Title: Rotorhead III Teeter Stop Assembly Screws		Compliance Category: A – MANDATORY B – RECOMMENDED C – OPTIONAL
AG-SB-2020-01-B-EN		
Applicability		
Aircraft type & model: AutoGyro Cavalon & MTO 2017 as listed	Affected Serial number(s): V00418 – V00424, RSUK-V00426, RSUK-V00428, V00430-432, RSUK- V00433, V00434, RSUK-V00449 and RSUK-V00450 M01762, M01763, M01873	
The maintenance manual to be referenced is this stated or subsequent issue.		As per AutoGyro website
This form is the response from AutoGyro GmbH either against a problem found in the product in service requiring a containment or rectification action, or as service information for aircraft modification incorporation. For help, contact AutoGyro on 49(0)5121 88056-00, or email airworthiness@auto-gyro.com .

It has been found that the Loctite securing the four M5x14 screws that retain the teeter stop (23794) to the mounting plate assembly (31800) may have been omitted (on a rotor head III).

(Pic.1)

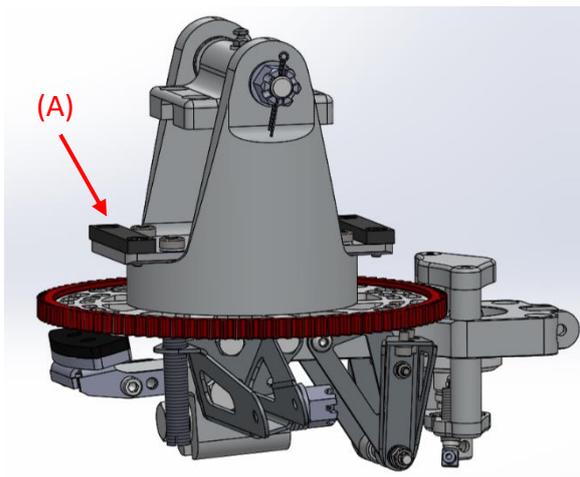
1. Ensure the aircraft has pressure in the rotor brake system and the rotor brake and wheel brakes are applied.
2. Either remove the rotor system, or remove the rotor bag and teeter the rotor system sufficiently to gain access to the teeter stop assembly (31800) (Pic. 1 (A)).
3. Remove one of the countersunk M5x14 screws from one of the teeter stops (23794) on the teeter stop plate assembly (31800) and inspect for Loctite residue on the threads (Pic. 2 (B)).
4. If Loctite residue is visible, clean the threads, re-apply Loctite 243 (21344) or local equivalent to the thread and re-fit the screw hand-tight, ensuring no deformation of the teeter stop.
5. If no Loctite residue is visible, apply Loctite 243 (21344) or local equivalent to the thread and re-fit the screw hand-tight, ensuring no deformation of the teeter stop. Carry out the same process to the other 3 screws.
